HISTORIC AND DESIGN REVIEW COMMISSION

August 18, 2021

HDRC CASE NO: 2021-385
ADDRESS: 233 FLORIDA ST
LEGAL DESCRIPTION: NCB 3006 BLK 4 LOT 18
ZONING: RM-4,H
CITY COUNCIL DIST.: 1
DISTRICT: Lavaca Historic District
APPLICANT: GROSS CHRISTIAN & LAURA
OWNER: GROSS CHRISTIAN & LAURA
TYPE OF WORK: Construction of a 2-story rear accessory structure
APPLICATION RECEIVED: July 23, 2021
60-DAY REVIEW: Not applicable due to City Council Emergency Orders
CASE MANAGER: Stephanie Phillips
REQUEST:

The applicant is requesting a Certificate of Appropriateness for approval to construct a new 2-story rear accessory structure. The first floor will house a garage with a footprint of approximately 924 square feet with a second story measuring approximately 617 square feet.

SITE PLAN

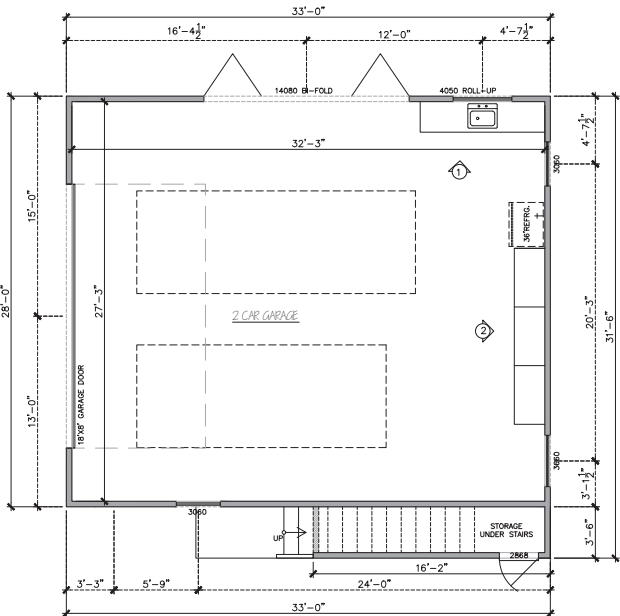
- b. **FOOTPRINT AND LOT COVERAGE** – The applicant has proposed to construct a new 2-story rear accessory structure. The overall footprint measures approximately 924 square feet. The existing primary structure has a footprint of approximately 1,500 square feet. According to the Guidelines, the addition of new structures should follow the historic development pattern in terms of footprint and total lot coverage should not exceed 50%. This lot is deep and narrow, and the structure is located behind the primary structure and follows the development pattern of the district. Staff generally finds the request acceptable due to the site-specific and district-specific characteristics.

- c. **SETBACKS AND ORIENTATION** – The applicant has proposed to construct a new 2-story accessory structure to the rear of the primary structure. As noted in finding a, the property is a corner lot and the new structure will be fully visible from the public right-of-way. As proposed, the structure will be located along the side property line and will be set back from the street by approximately 10 feet. A cedar privacy fence will partially obscure the structure from both Florida and Staffel streets. According to the Guidelines, setbacks for rear structures should follow the predominant development pattern of the historic district. The new construction generally follows the historic development pattern of the district, which features a mixture of larger primary structures and subordinate rear accessory structures and vice versa. Staff finds the request appropriate. The applicant is responsible for complying with zoning setback requirements and obtaining a variance from the Board of Adjustment if applicable.

- i. **SITE MODIFICATIONS** – The site plan includes items that are eligible for administrative approval, including the installation of an inground pool surrounded by concrete. However, a portion of the concrete extends beyond the 10' setback. The proposed impervious lot coverage is substantial and should be reduced wherever feasible to ensure proper drainage. Staff finds that the new concrete should be contained within the 10 foot setback recommends that the applicant explore ways to reduce the proposed impervious cover via landscaping, decomposed granite or another pervious ground material, or similar.

- viii. That the board and batten siding features boards that are twelve (12) inches wide with battens that are 1 – ½” wide.
- ix. That the applicant reduce the proposed concrete located within the 10’ side setback and explore ways to reduce the proposed impervious cover via landscaping, decomposed granite or another pervious ground material, or similar as noted in finding i. An updated final site plan is required to be submitted to staff for review and approval prior to the issuance of a certificate of Appropriateness.

- x. That the applicant comply with zoning setback requirements a obtains a variance from the Board of Adjustment if applicable.

EXTERIOR ELEVATIONS

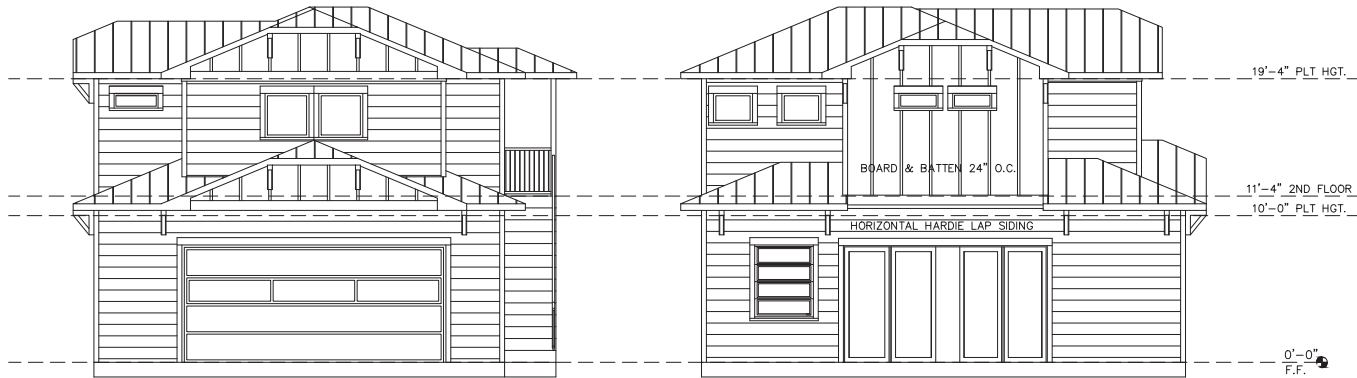
- d. **MASSING AND SCALE** – The proposed rear accessory structure is 2-stories in height. Per the drawings, the overall ridge height is not indicated, but the height appears to be approximately 24'. The existing structure has an overall height of approximately 30'. Per the Guidelines for New Construction, new garages and outbuildings should be designed to be visually subordinate to the principal historic structure in terms of their height, massing, and form. Heights and scale should be consistent with historic development patterns of rear accessory structures and garages in the district. The property immediately to the north of the home features a 2-story rear accessory structure of a similar height as the proposed structure. Staff generally finds the height appropriate with the stipulations listed in the recommendation.

submitted elevations, the applicant has proposed one over one windows and door configurations that are consistent with historic patterns, along with smaller windows and fixed windows that deviate from established patterns. The applicant has also proposed a double-width garage door. Staff finds that the small horizontal windows and single pane windows should be modified to feature a one over one configuration and traditional proportions and dimensions. Staff also finds that the applicant should install two single-bay garage doors in lieu of the proposed double-width garage door to be more consistent with the Guidelines and established rear accessory patterns in the immediate vicinity and in the district, particularly those that feature corner-lot or multi-street visibility and access.

- f. **ROOF FORM** – The proposed rear accessory structures will utilize a multi-roof configuration, including a primary hip and several clipped gables. The first story roofline is proposed to be a series of projecting low sheds, hips, and clipped gables. The overarching roof configuration is predominantly Craftsman in style. The primary structure is Folk Victorian and does not feature clipped gables. Staff finds that the clipped gables should be eliminated in favor of traditional gables as found on the primary structure. Staff also finds that the clipped gables should be eliminated on the first floor level in favor of a traditional shed roof. The proposed roof also features boxed gable ends and faux bracketing, the former which is very modern and the latter which is very Craftsman and again is not found on the primary structure. Staff finds that these details should be eliminated in favor of traditionally extending eaves. Exposed rafter tails may be incorporated in lieu of the faux brackets where feasible or appropriate.

- g. **MATERIALS** – The applicant has proposed to use composite lap siding and board and batten siding, standing seam metal roofing, and aluminum clad wood windows. Staff finds this generally appropriate with the stipulations listed in the recommendation.

- i. That the applicant eliminate the clipped gable roof forms in favor of traditional gables on the second story and shed roofs on the first story as noted in finding f.

- ii. That the decorative brackets and gable ends be eliminated in favor of extending eaves as noted in finding f.
- iii. That the fenestration pattern be modified to feature one over one windows and more traditional proportions and dimensions as noted in finding e. The proposed long horizontal windows are not appropriate. Paired windows must feature a true ganged condition and traditional sill and trim details.

- v. That the applicant install two single bay garage doors in lieu of the proposed double-width overhead garage door as noted in finding e. A final material specification for the garage door is required to be submitted for final approval.

- vii. That the siding be woodlap or horizontal composite with a maximum reveal of 6 inches. If composite siding is used, a smooth finish must be used. Faux wood grain is not permitted.
